# SERVICE BULLETIN

**Subject: GS-X Nexgen Rear Display Upgrade Package****Date: 8/18/10****Bulletin No. SB10-10**

Brunswick now offers a Rear Display Upgrade Package, part number 47-861048-000, for GS-X pinsetters. This display mounts on the side of the elevator and is being made available to provide for ease of viewing and for use of the functions that are currently available on the Nexgen Box. Included with this letter is a copy of Installation Instructions, part number 47-902101-000, that will be needed for the installation.

*Figure 1 - Modified CPU with Heat Sink*

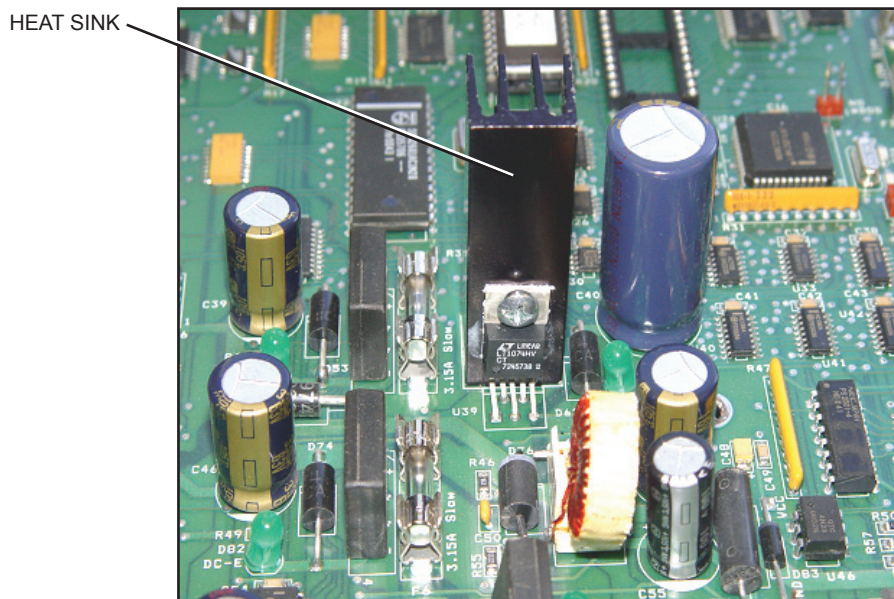
1. Disconnect power to the pinsetter by turning off the main power switch and unplugging the power cord to the Nexgen Box.
2. Locate the CPU PCB board and check if Regulator U39 has a black heat sink attached and is soldered on the board. Refer to *Figure 1*.

- a. If the CPU PCB has the heat sink soldered onto the board, the board will operate as needed and the Rear Display package can be installed.
  - b. If the CPU board does not have this heat sink, it will need to be modified as it will not communicate with the Rear Display unit.
3. If a heat sink is not present, the CPU PCBs will need to be exchanged with upgraded PCBs. To receive exchange PCBs, contact the Brunswick Electronic Repair Center or an authorized Exchange Depot. Please note that an exchange fee will be charged for each board. You can contact the Electronic Repair Center by calling 1-800-937-2695 or 231-725-4966, or sending an e-mail to [erc@brunbowl.com](mailto:erc@brunbowl.com) to receive a CPU upgrade replacement and current pricing information.

*Figure 1 - Modified CPU with Heat Sink*

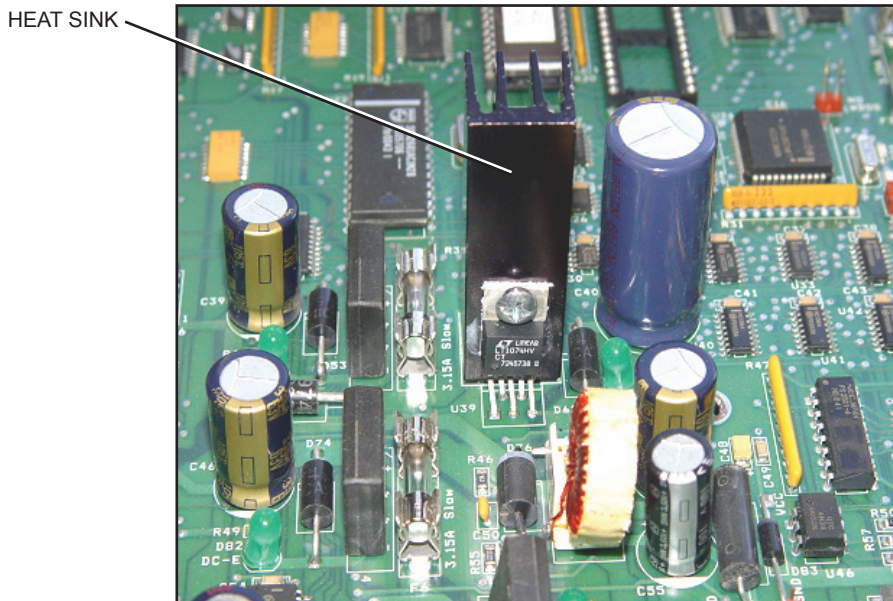
2. Locate the CPU PCB board and check if Regulator U39 has a black heat sink attached and is soldered on the board. Refer to *Figure 1*.

- a. If the CPU PCB has the heat sink soldered onto the board, the board will operate as needed and the Rear Display package can be installed.
  - b. If the CPU board does not have this heat sink, it will need to be modified as it will not communicate with the Rear Display unit.
3. If a heat sink is not present, the CPU PCBs will need to be exchanged with upgraded PCBs. To receive exchange PCBs, contact the Brunswick Electronic Repair Center or an authorized Exchange Depot. Please note that an exchange fee will be charged for each board. You can contact the Electronic Repair Center by calling 1-800-937-2695 or 231-725-4966, or sending an e-mail to [erc@brunbowl.com](mailto:erc@brunbowl.com) to receive a CPU upgrade replacement and current pricing information.
